RE: In the Matter of the Proposed Listing of
 Richardson Flat Tailings, Summit County, Utah,
 On the National Priorities List for Uncontrolled
 Hazardous Waste Sites, Proposed Rule No. 12

IN THE MATTER OF THE PROPOSED)	COMMENTS OF UNITED PARK
LISTING OF RICHARDSON FLAT)	CITY MINES COMPANY IN
TAILINGS, SUMMIT COUNTY, UTAH,)	OPPOSITION TO PROPOSED
ON THE NATIONAL PRIORITIES LIST)	RULE

United Park City Mines Company ("United Park") hereby respectfully submits its comments in opposition to the proposal of the Environmental Protection Agency ("EPA"), published in the Federal Register of February 7, 1992, to list Richardson Flat Tailings, Summit County, Utah, on the National Priorities List ("NPL").

FIG. 2

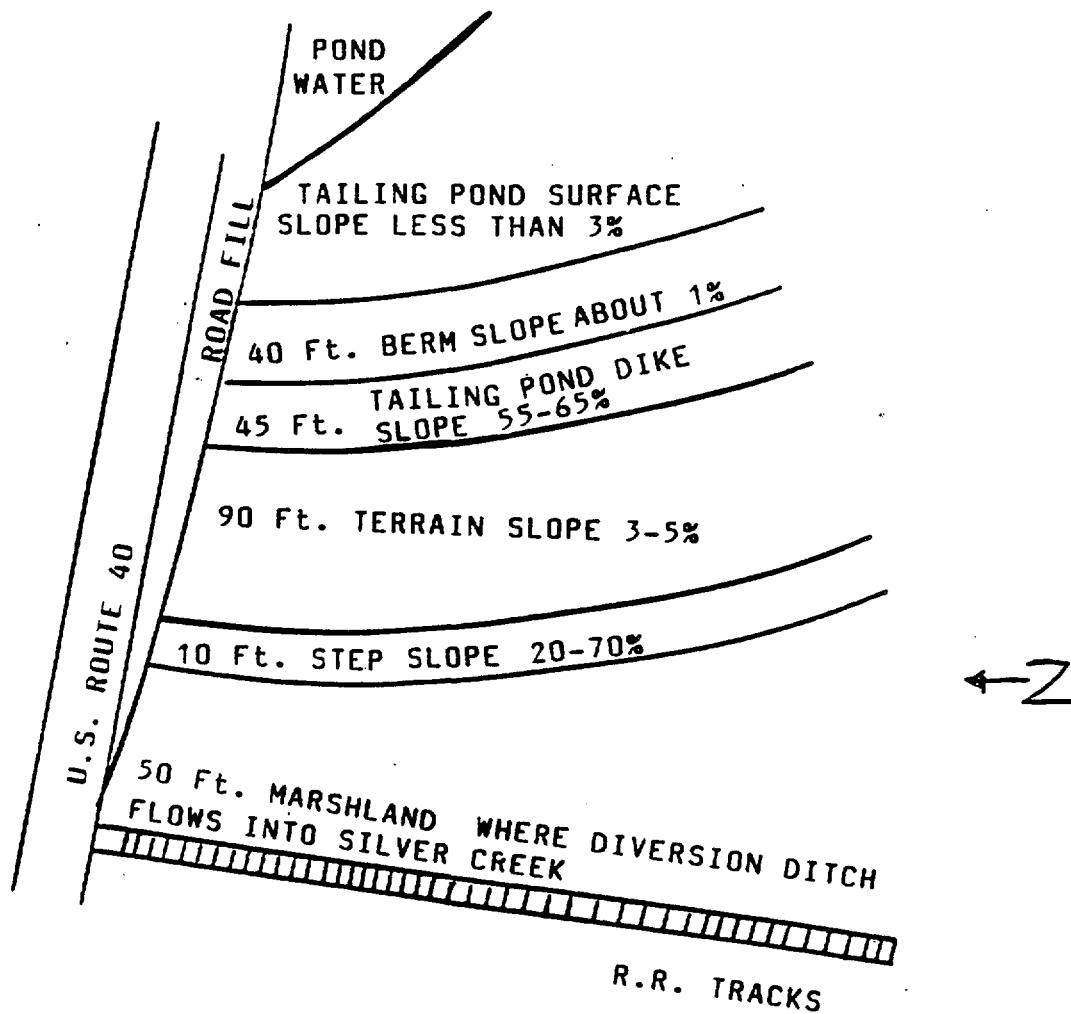
An examination of the Sample Location Map (second Figure 2) in the 1989 Supplement Site Inspection Report shows the separate and unrelated locations of the two sites. The Tailings Impoundment is located more than 500 feet east of Silver Creek and east of and across two elevated railroad grades, while the Floodplain Sediments are located west of Silver Creek, between the access road and the western railroad grade.

not "slumping" into the creek and was not in contact with the creek. See 1989 Supplemental Site Inspection Report, Ref. 4, Table 3 and second Figure 2 (Sample Location Map). Even EPA's Sample Location Map (1989 Supplemental Site Inspection Report, the second Figure 2) does not show tailings in contact with Silver Creek.

Examination of the site maps (Reference 4, second Figure 2) clearly illustrates the separate and unrelated locations of the two sites. The Richardson Flat tailings are located more than 500 feet east of Silver Creek, and east of two railroad grades; while the floodplain sediments are located west of Silver Creek, between the access road and the westernmost railroad grade. The distance separating the two sites is more than 600 feet and the sites are separated by significant topographic features (the tailings dam, Silver Creek, and two railroad grades).

CORRECT LOCATION OF SAMPLE RFT-TA-3

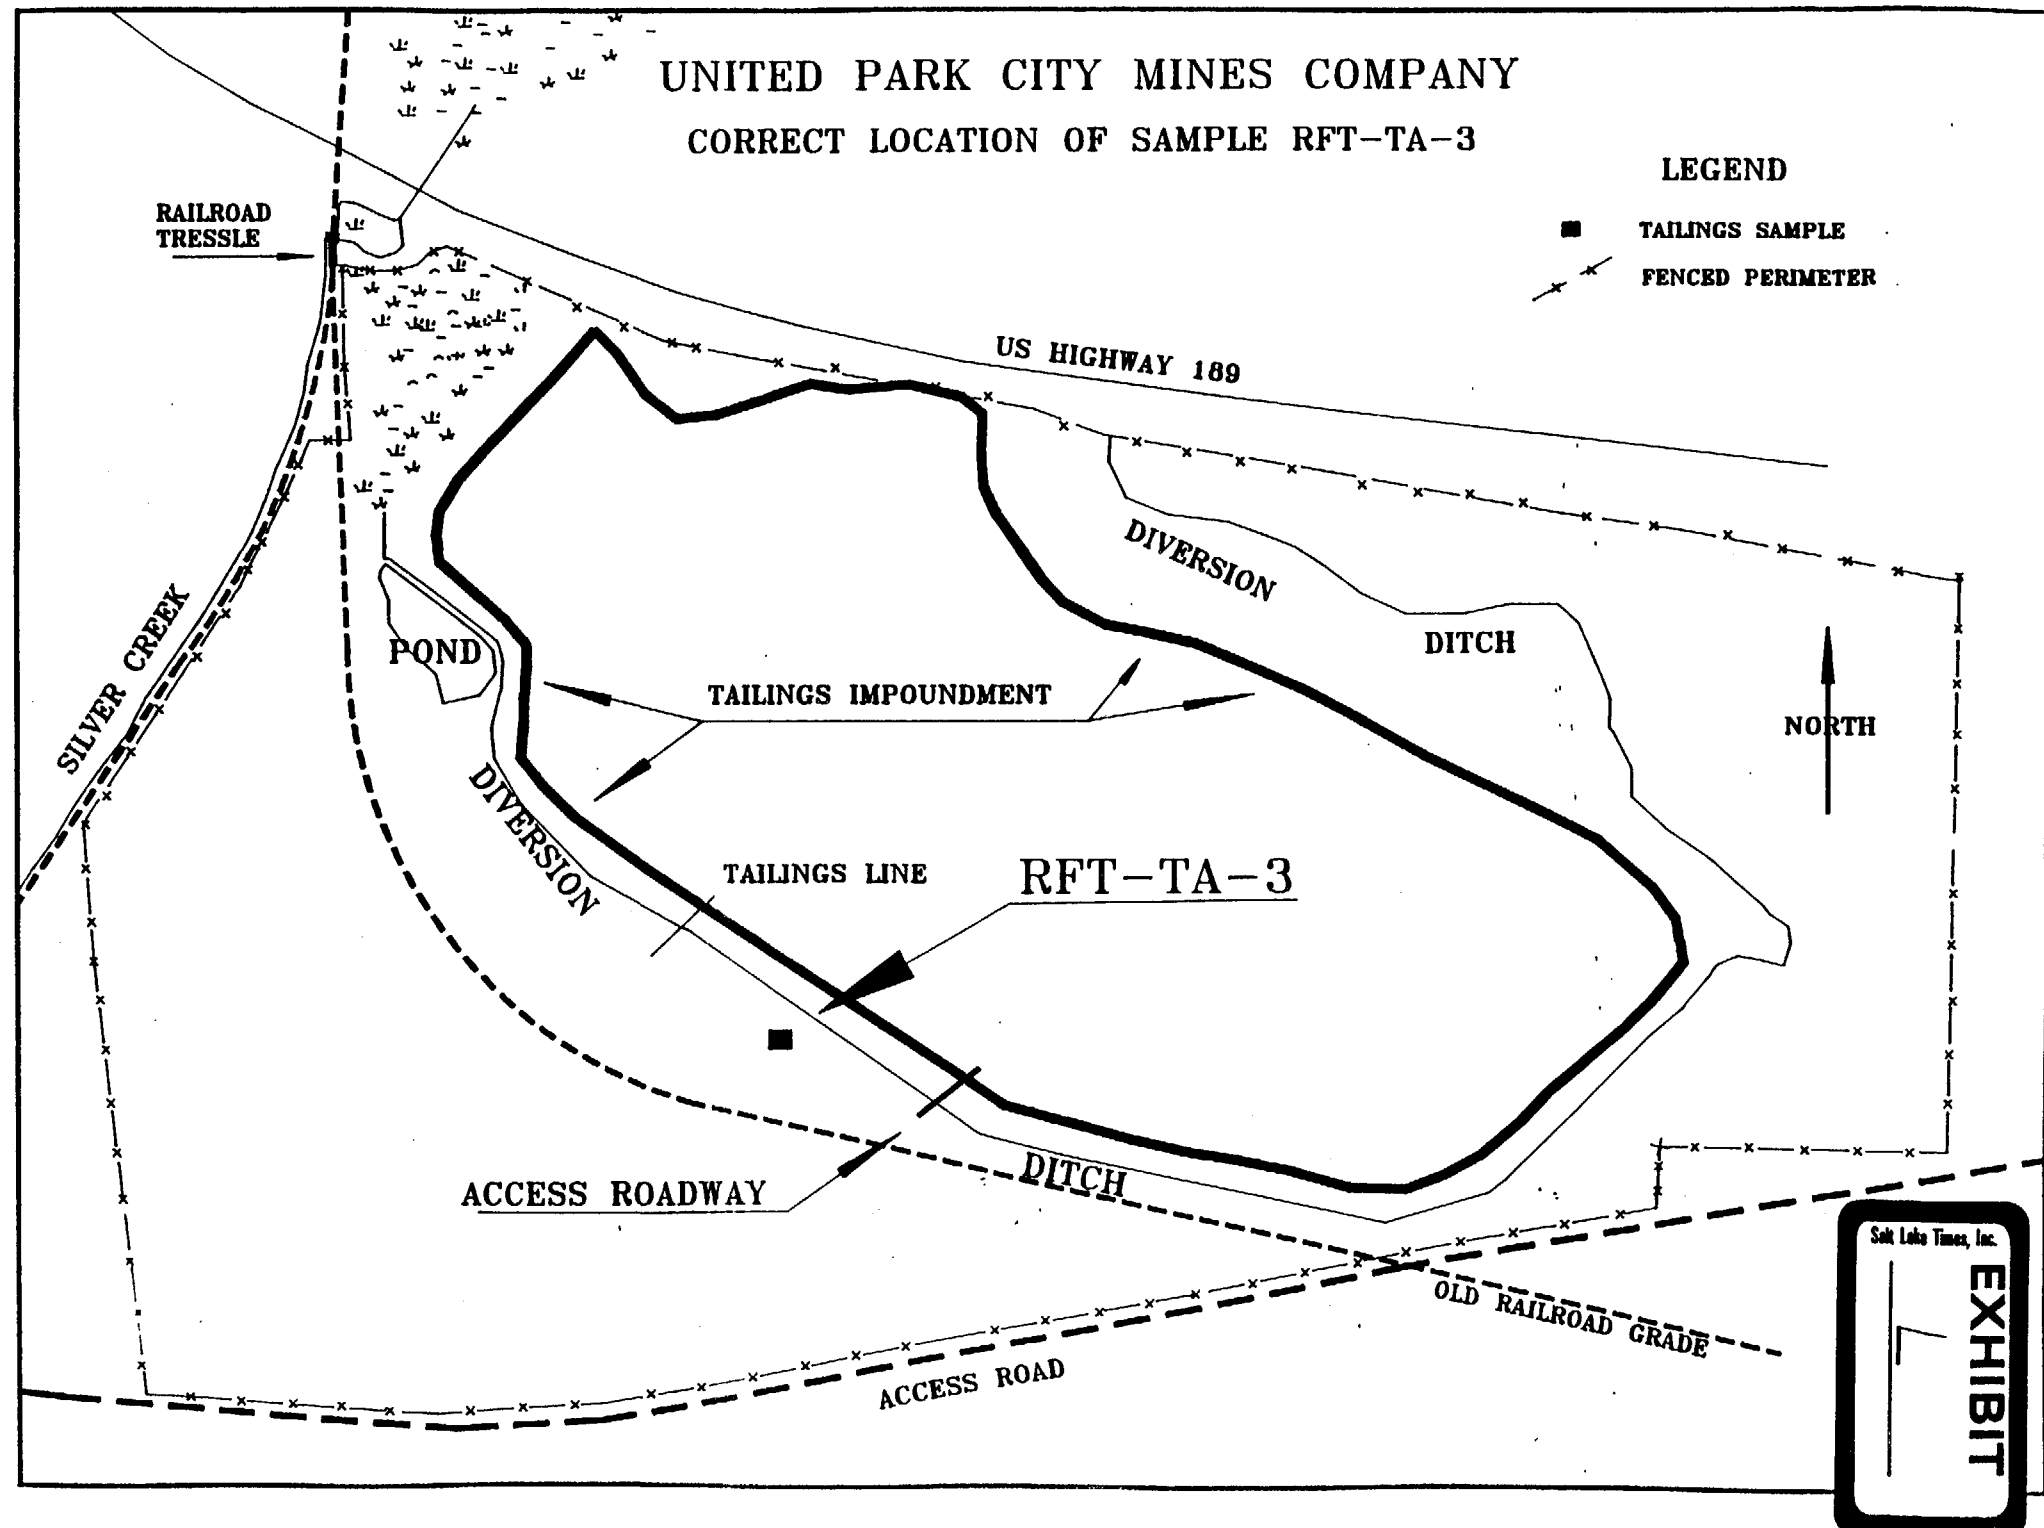
However, sampling site RFT-TA-3 of the 1989 Supplemental Site Inspection is not located west of and adjacent to United Park's slurry pipe or near the Diversion Ditch. Sampling site RFT-TA-3 is located over 400 feet to the southeast of the point where it is incorrectly shown on UBSHW's Figure 1 Map and on the Sample Location Map in the 1989 Supplemental Site Inspection Report (EPA's Ref. 4, the second Figure 2).

The best evidence of the location of sampling site RFT-TA-3 is EPA's own Photo 4, captioned "South Facing Photo of FIT Member Collecting Tailings Sample RFT-TA-3," in the 1989 Supplemental Site Inspection Report (EPA's Ref. 4, Photo 4). United Park's Map, entitled "Correct Location of Sample RFT-TA-3" and attached hereto as Exhibit L, accurately reflects the location of sample RFT-TA-3 and of EPA's Photo 4.

As revealed in EPA's Photo 4, the actual site of sample RFT-TA-3 is in a different location from that identified on the UBSHW and 1989 FIT maps and in UBSHW Photo 2 (a photograph showing the slurry line). EPA's Photo 4 shows sample RFT-TA-3 being taken in a depression with a mound of naturally occurring alluvial material clearly depicted in the right of the photograph. This mound of alluvial material separates the actual sampling location of RFT-TA-3 from the purported sampling site referenced in UBSHW's Figure 1 Map, UBSHW's Photo 2, and the 1989 FIT's Sample Location Map. Therefore, the material which is located at the purported sampling location cannot be characterized as the same material as that in the area where sample RFT-TA-3 was actually taken.
